**The Corporation of the District of Saanich**

# Report

**To:** Mayor and Council  
**From:** Sharon Hvozdzanski, Director of Planning  
**Date:** October 29, 2021  
**Subject:** Development Permit Application for a Garden Suite  
**File:** DPR00885 • 599 Tait Street

Figure 3: West Elevation (from plans by Backyard Bungalows)

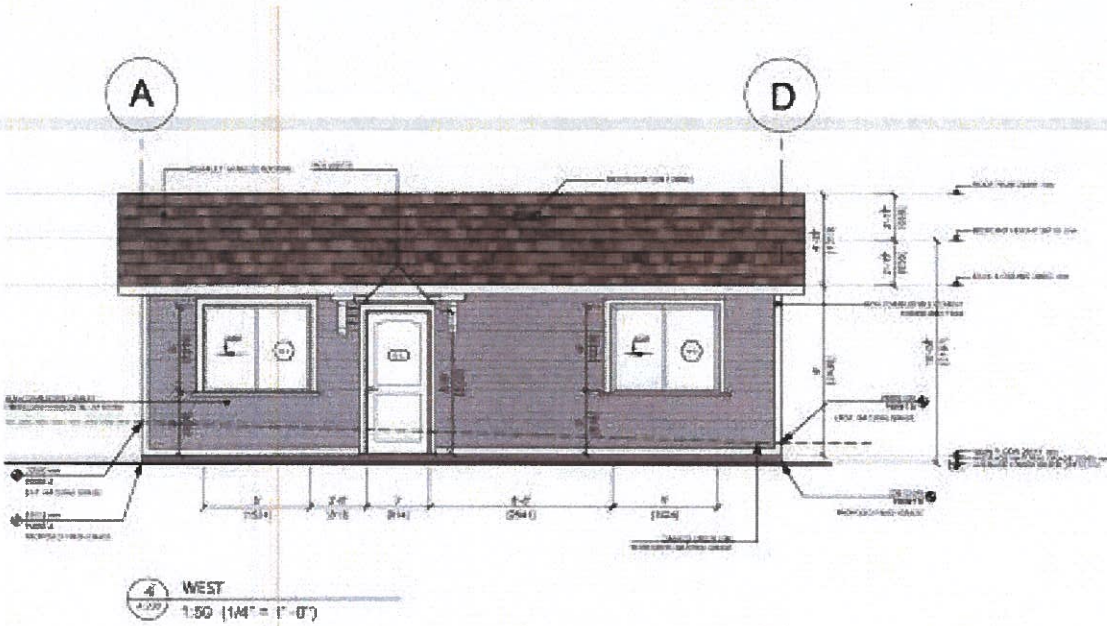
The applicant is proposing to build a one-storey garden suite. The proposed garden suite is one-storey building with a simple, gable roof facing toward the interior of the lot. The siding is cement fibreboard horizontal lap siding with cement fibreboard shingles in the gable ends (see Figures 3, 4, 5, and 6).

The proposed garden suite is a one-storey building with low-pitch gable roof, clad in horizontal lap concrete fibreboard that fits well with the neighbourhood. There are an adequate number of operable windows to provide natural light and ventilation. There are no window or door openings on the south elevation, the side that directly fronts the nearest neighbour, providing privacy and reducing overlook.

Figure 4: North Elevation (from plans by Backyard Bungalows)

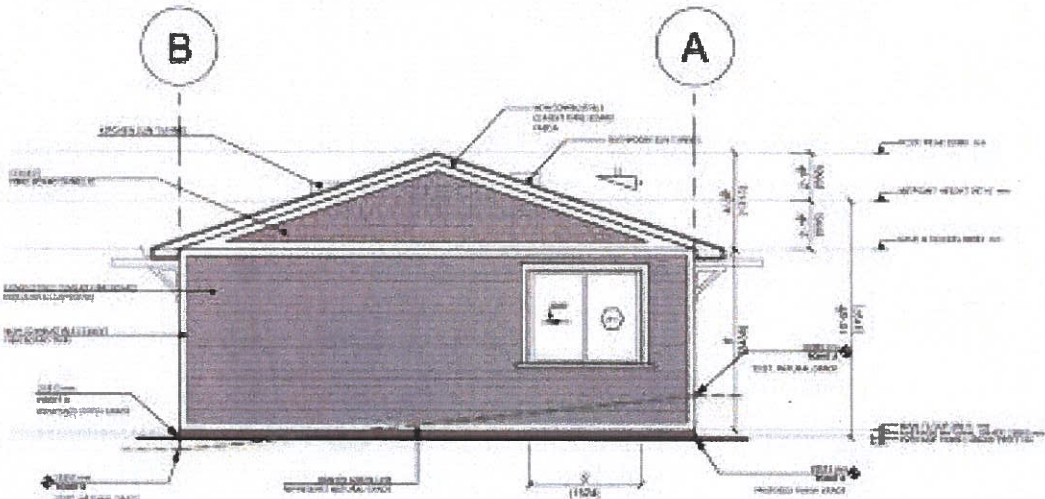
The roof overhang at the entrance provides weather protection. The garden suite has unit numbering that is illuminated by recessed exterior lighting on the north building wall at the Tait Street entrance. The suite entry is clearly legible from the street.
